FINAL FINDINGS AND DECISION BY THE DESIGN COMMISSION RENDERED ON May 4, 2017

CASE FILE NUMBER: LU 17-107048 DZM
PC # 16-246014
5615 SW Hood Ave

The proposal is for a new Cross-Laminated Timber framed 4-story office building with ground floor retail and partially below-grade tuck-under parking behind retail on an 8,500 square foot site.

GROUND FLOOR PLAN

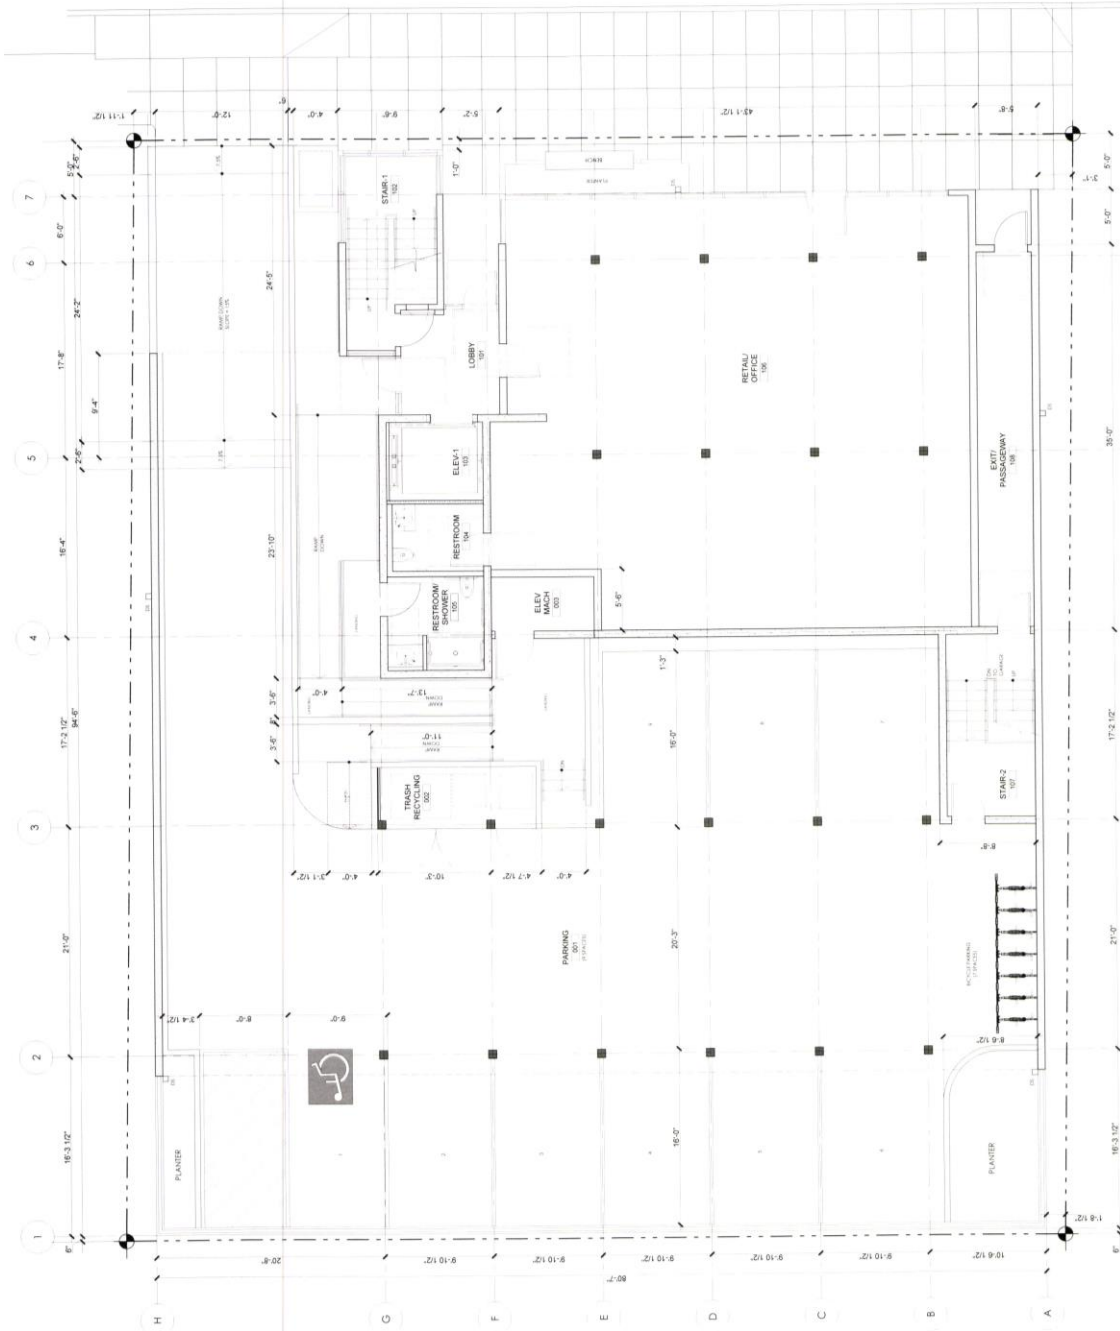
At the May 5, 2017 Land Use Review Hearing, the Design Commission determined that the entrances to the elevator lobby and retail space were not designed in a manner to be sufficiently prominent, safe or comfortable – the elevator lobby entrance was too narrow (approximately 3'-6") and un-protected by canopy cover, and the retail entry canopy was too low. Therefore, with the following conditions of approval this guideline is met:

- C. Expand the width of the street-facing entrance to the elevator lobby to align as closely as possible with the level 2 window mullions.
- D. Add a canopy above the street-facing entrance to the elevator lobby aligned as closely as possible with the underside of the second floor structure.

- E. Raise the canopy at the retail entry aligned as closely as possible with the underside of the second floor structure.
- F. No field changes allowed.
